Addendum No. 1

City of Coquitlam
Tender 87413

Johnson/Glen & Lincoln/Pipeline PRVs

Issue Date: October 31, 2023
(Consists of 4 Pages)

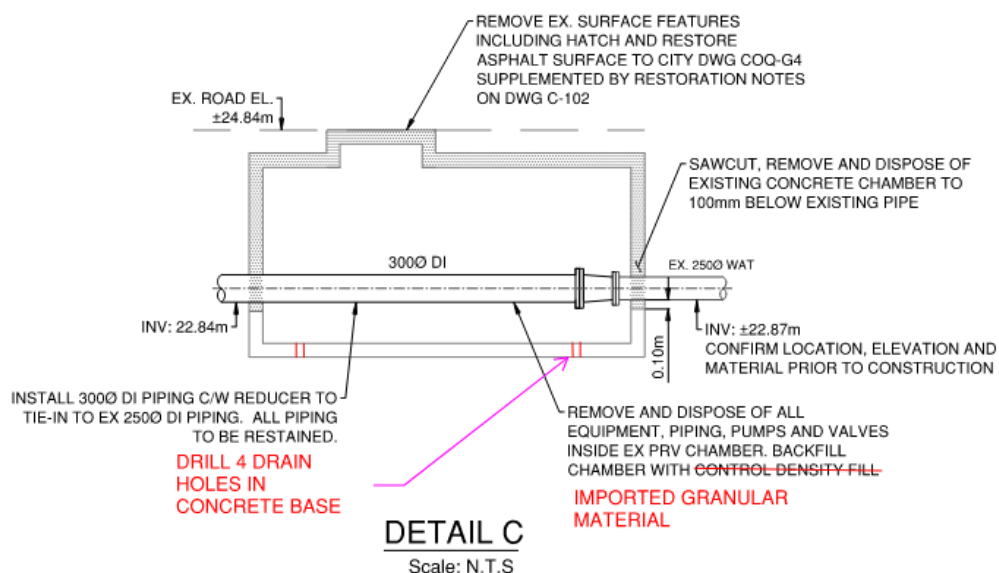
REPLACE DETAIL ON JOHNSON AND GLEN PRV STATION, WATERMAIN PLAN AND PROFILE, SHEET C101. Detail applicable for decommissioning and removal of Johnson/Glen and Lincoln/Pipeline PRVs.
